**MK 3 Ships Inertial Navigation — Maintenance
Hint**

COMMUNICATIONS

NAVSEA 0967-LP-000-0010

Figure 1

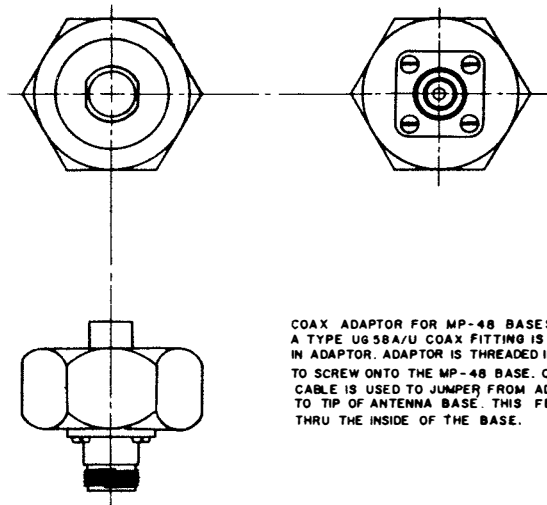
By adding a coax adapter to the bottom of the antenna base, a coax jumper is made up at the base of the antenna and is fed through to the bottom of the antenna and a tip is soldered to the end of the coax cable. See Figure 1.

COAX ADAPTOR FOR MP-48 BASES
A TYPE UG 58A/U COAX FITTING IS USED
IN ADAPTOR. ADAPTOR IS THREADED INSIDE
TO SCREW ONTO THE MP-48 BASE. COAX
CABLE IS USED TO JUMPER FROM ADAPTOR
TO TIP OF ANTENNA BASE. THIS FEEDS
THRU THE INSIDE OF THE BASE.

Figure 1. Wiring Connections AN/SYA-4 Foot Pedal Switch

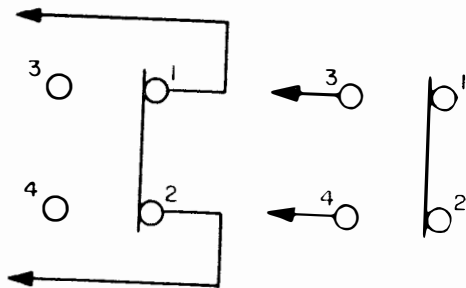
5. Remove the leads from contacts 1 & 2 and attach them to contacts 3 & 4 of the switch. See figure 1.

Figure 1 — Wired "OR" Gate Testing Device.

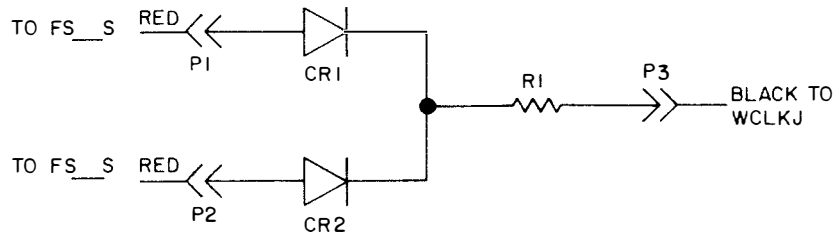
capability. This capability can be provided by use of an "OR" gate test device assembled as shown in figure 1. Use of the following procedure will cause the BEM to halt at specific state counter conditions to allow observation of register contents and the proper sequencing of the state counter:

FIGURE 1.--Terminal strip markings on type CQC-23496 remote control indicator unit

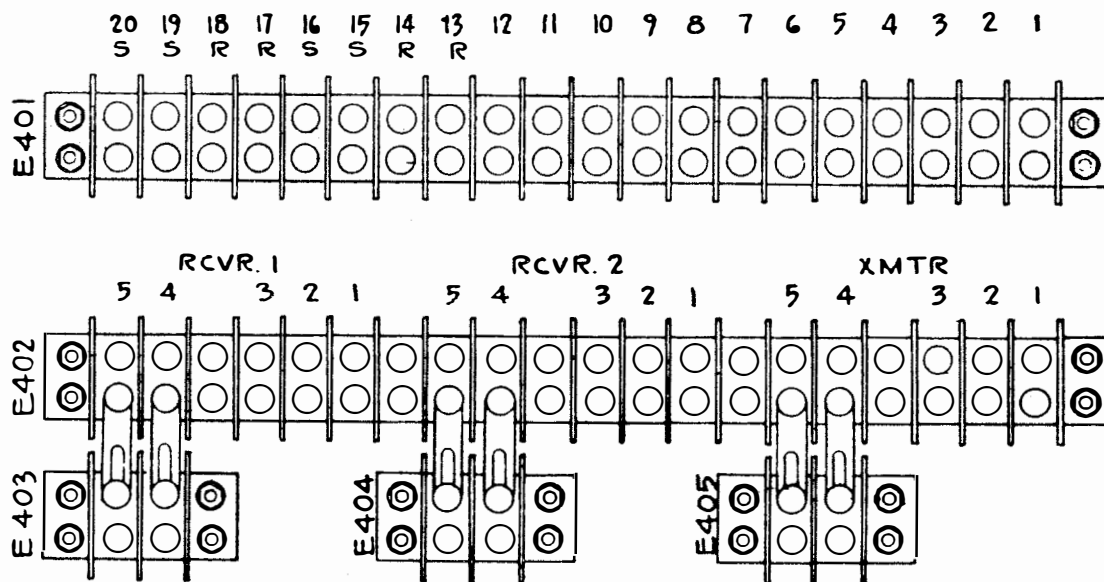
The Bureau has recently received information that several Remote-Control Indicator Units Type-23496 were found to have no identification markings for the terminal strips mounted in the back of the cabinets. For the convenience of those installing activities finding this condition, the accompanying diagram is published. Additional copies are available from the Bureau of Ships.

FIGURE 1.-- Type -23496 control indicator unit modified for handset extension

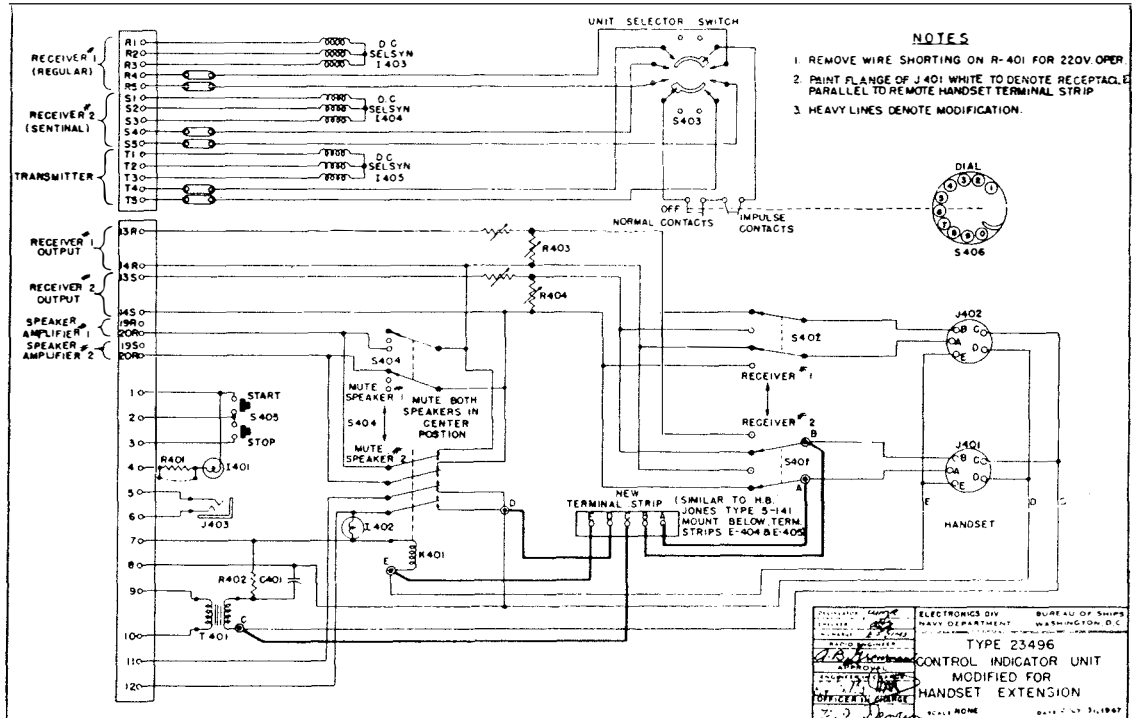
facilitate wiring. The back of these points is indicated in Figure 1 by a circle and designated by a letter which corresponds to the pin designation in the handset jack. The wiring to the new terminal strip is drawn in heavy lines. Inasmuch as there are two handset receptacles in the -23496, the Bureau desires that the flange of receptacle J-401, to which the new terminal strip is set parallel, be painted white.

FIGURE 1.--Jumpers installed across input terminals of type 49131 speaker-amplifiers

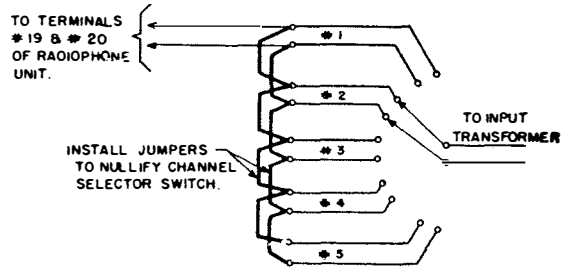
To eliminate the possibility of the above condition, it is recommended that all types 49131 units installed on single communication circuits be modified according to Figure 1. Jumpers are installed across the input terminals as indicated, permitting the speaker to operate regardless of the position of the switch.

FIGURE 1.--The center-tap lead on the primary of input transformer should be removed

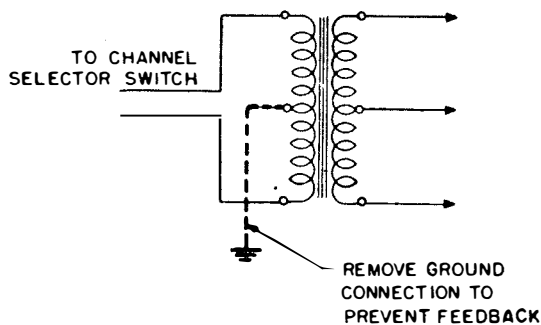
- As a temporary modification only, to preclude the possibility of this trouble recurring, the reactor was removed and replaced with a 250-ohm 2-watt composition resistor. No noticeable hum in the output with either a-c or d-c power supply. Equipment now operates satisfactorily.
